PG&E Letter DCL-03-047

Docket No. 50-275, OL-DPR-80
Docket No. 50-323, OL-DPR-82
Diablo Canyon Units 1 and 2
Response to NRC Request for Additional Information Regarding License
Amendment Request 02-03, "Spent Fuel Cask Handling"

**PG&E Response to NRC Request for Additional Information Regarding License
Amendment Request 02-03, "Spent Fuel Cask Handling"**

SAFETY ANALYSIS REPORT
DIABLO CANYON ISFSI
FIGURE 5.1-1 (2 of 3)
OPERATION SEQUENCE FLOWCHART FOR
CASK SYSTEM LOADING, SEALING,
TESTING, AND STORAGE

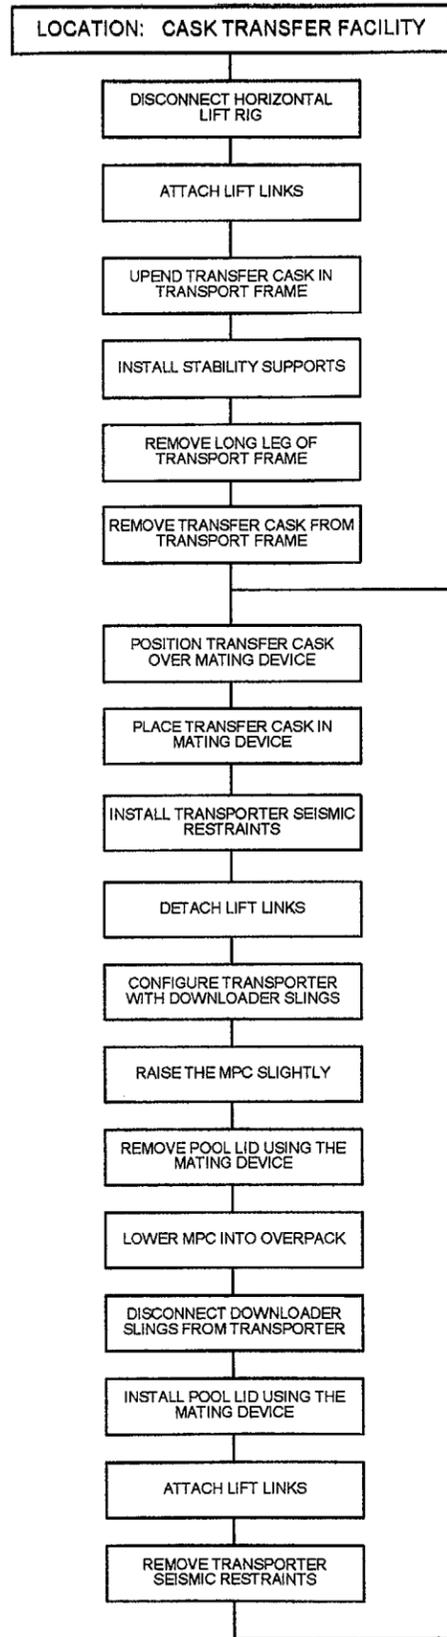
The Diablo Canyon Power Plant (DCPP) license amendment request to revise the DCPD updated final safety analysis report (UFSAR) regarding its control of heavy loads program proposes to eliminate the spent fuel cask exclusion zone. The UFSAR restricts cask movement to the portion of the spent fuel pool which is over the cask recess area. The defense-in-depth approach within NUREG-0612, "Control of Heavy Loads at Nuclear Power Plants," states that despite the increase reliability of the overhead handling system licensees should (1) provide sufficient operator training, handling system design, load handling instructions, and equipment inspection to assure

reliable operation of the handling system; and (2) define safe load paths through procedures and operator training so that to the extent practical heavy loads avoid being carried over or near irradiated fuel or safe shutdown equipment. Provide your basis for eliminating the cask exclusion area? Demonstrate how the defense-in-depth philosophy described will be maintained through your cask handling operations supporting your proposed independent spent fuel storage installation (ISFSI).

An operational sequence depicting the cask handling operations is presented in the enclosed Diablo Canyon ISFSI SAR Figure 5.1-1, which was previously submitted in PG&E Letter DIL-01-002 dated December 21, 2001 under Docket No. 72.26. Using LAR Figures 8 and 9 along with the sequence presented, provides a "pool to pad" map of cask handling operations.
